Contract Change Order # 3

Project Name: <u>Lynn Lane WWTP Disinfection Improvements</u>	Project Number: <u>S 1905</u>
Project Location: <u>Broken Arrow OK</u>	Date of Application: <u>Friday, February 14, 2025</u>
Contractor: <u>Crossland Heavy Contractors</u>	Submitted By: <u>2/14/2025</u>

Lynn Lane WWTP Disinfection Improvements
CO No. 2: Emergency By-Pass System

DRAWING NUMBER
20-E301
SHEET
NUMBER

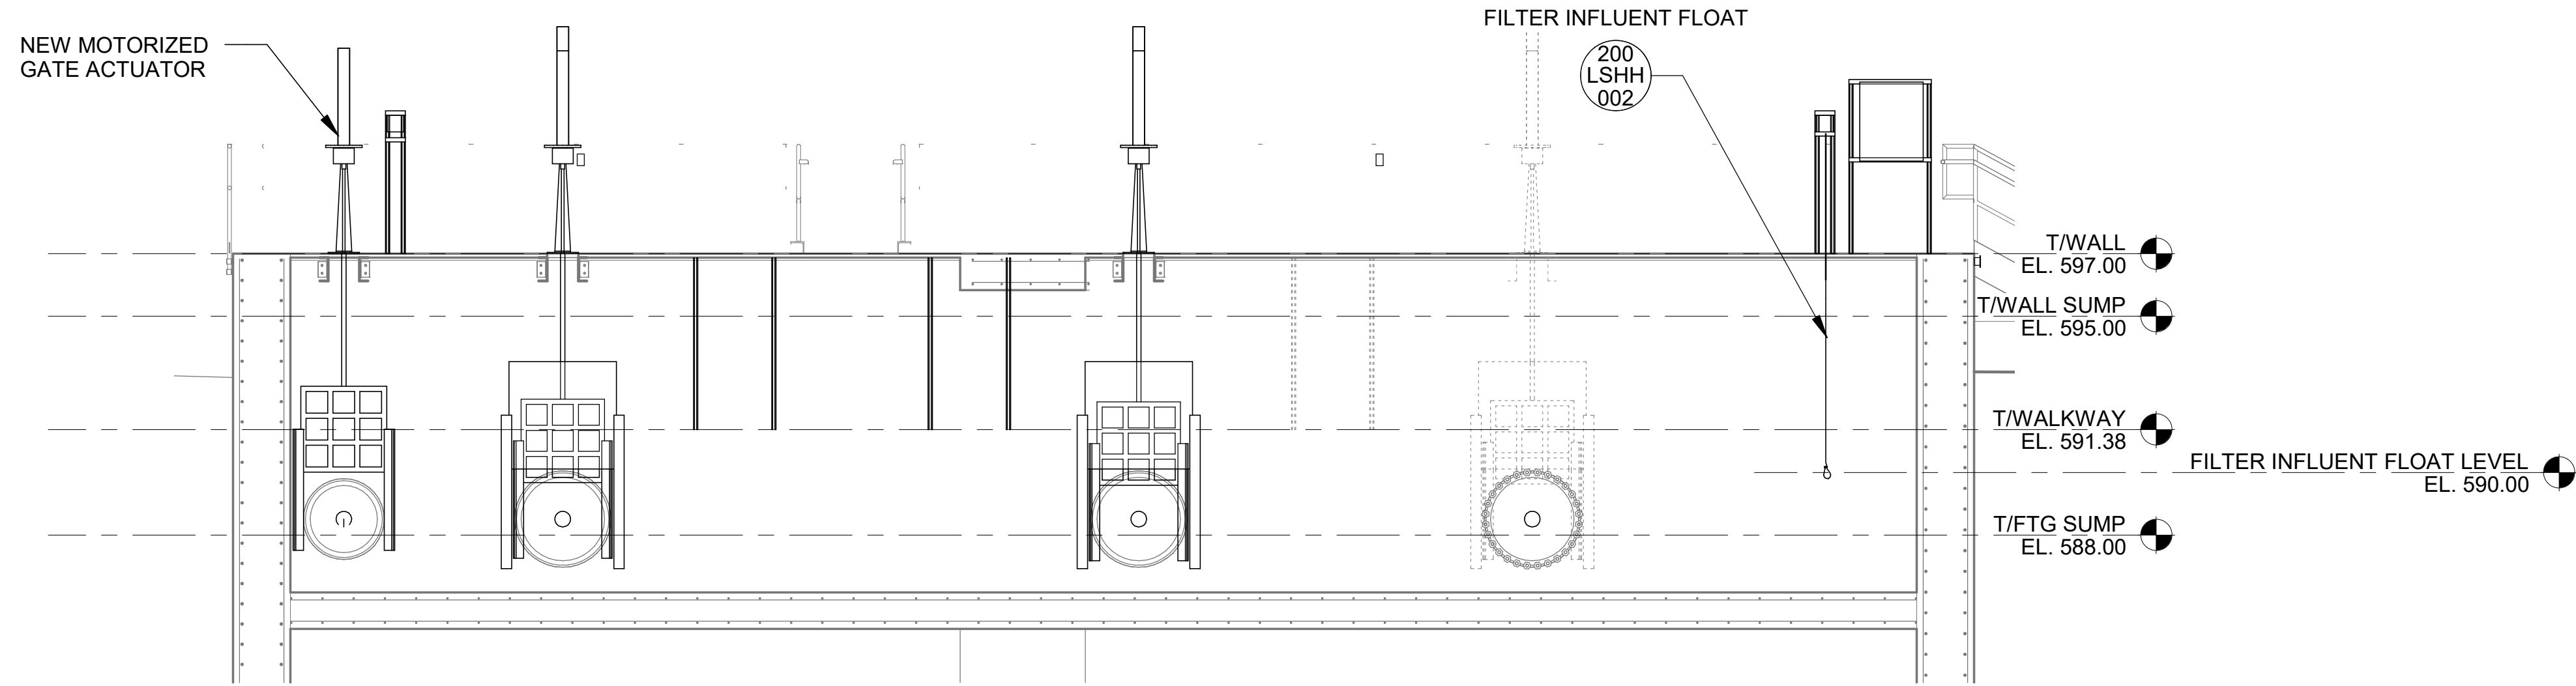
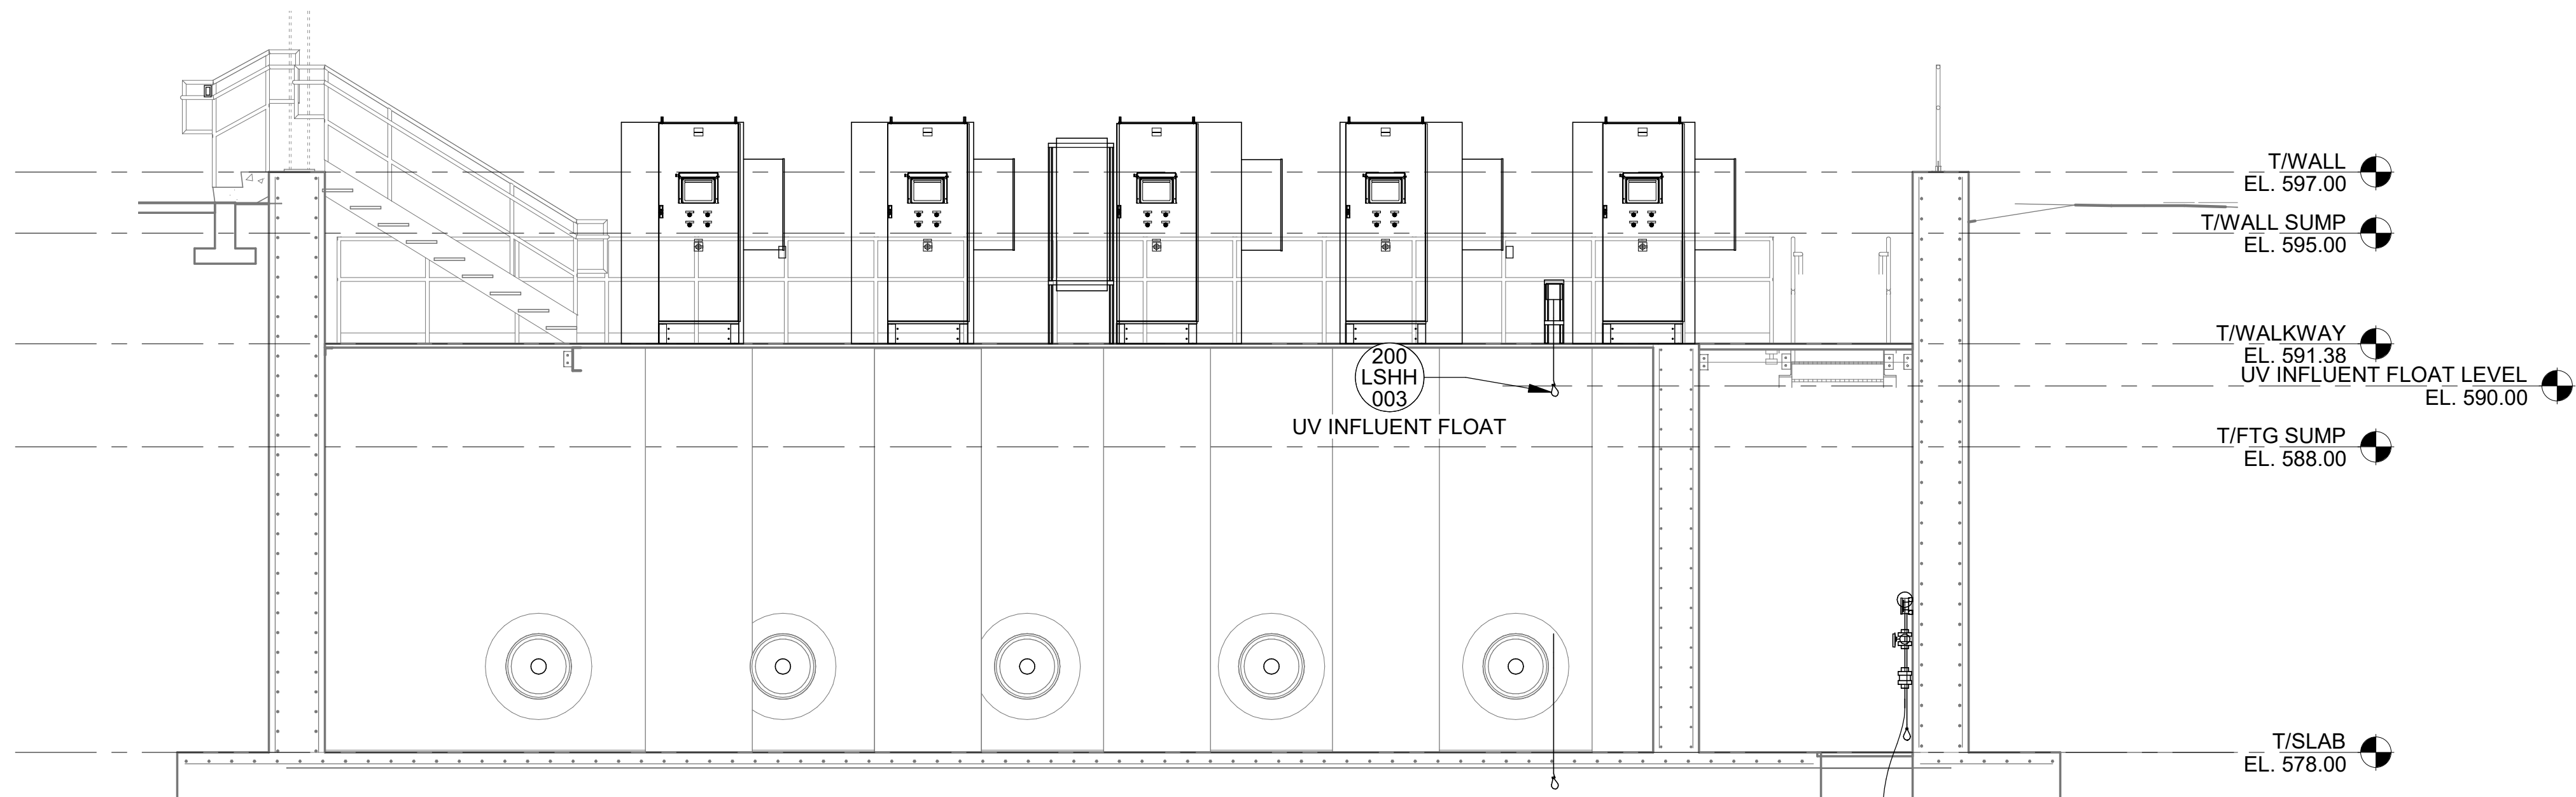
When the FILTER INFLUENT HIGH LEVEL is detected from float switch 200LSHH02, 11-PLC opens the filter bypass gate.

If the UV INFLUENT HIGH LEVEL is detected from float switch 200LSHH03 a “NO FLOW” indication is communicated to the UV control panel via Ethernet from the SCADA system.

Gate actuator and (2) float switch installations.

Conduit and conductors from (a single 14GA 15-conductor cable or equal would work) the UV/Filter area to the existing 11-PLC control panel. (We need confirmation of an existing spare conduit in the duct bank that was just installed between the new disinfection facility and existing electrical building where 11-PLC is located.)

Power conduit and conductors from 480V panel 20DP2 to gate actuator.
